**ADDENDUM #2**

**HALL COUNTY COURTHOUSE  
HVAC & RESTROOM RENOVATIONS**

## ADDENDUM NO. 2

# HALL COUNTY COURTHOUSE – HVAC UPGRADES

SECOND FLOOR PLAN - HVAC  
NOT TO SCALE

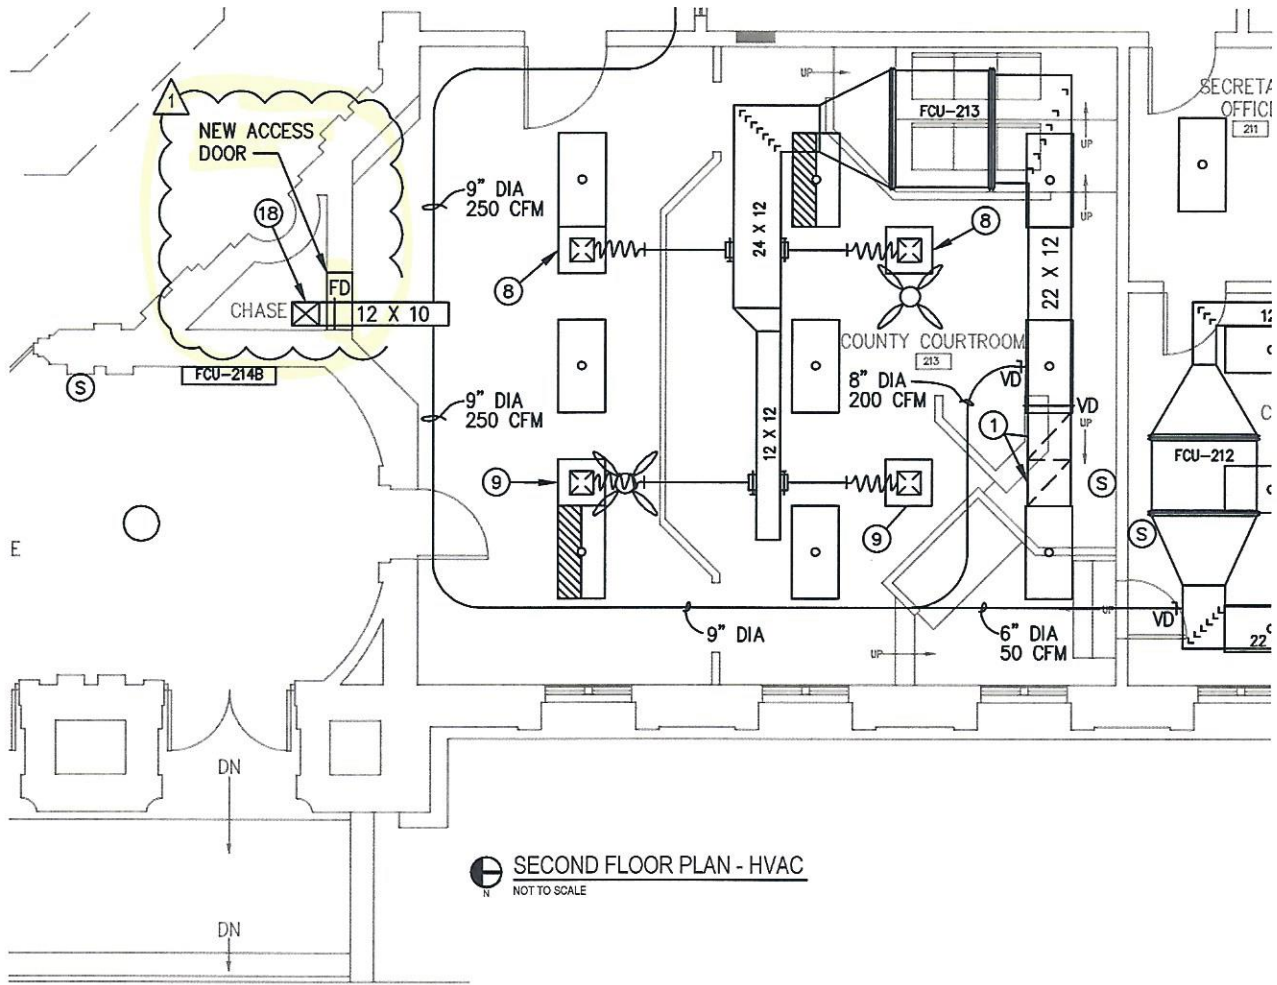
#### **Sheet M3.2: Second Floor Plan – HVAC**

- a. See the attached drawing for the addition of an access door into the southwest chase located in County Courtroom 213.
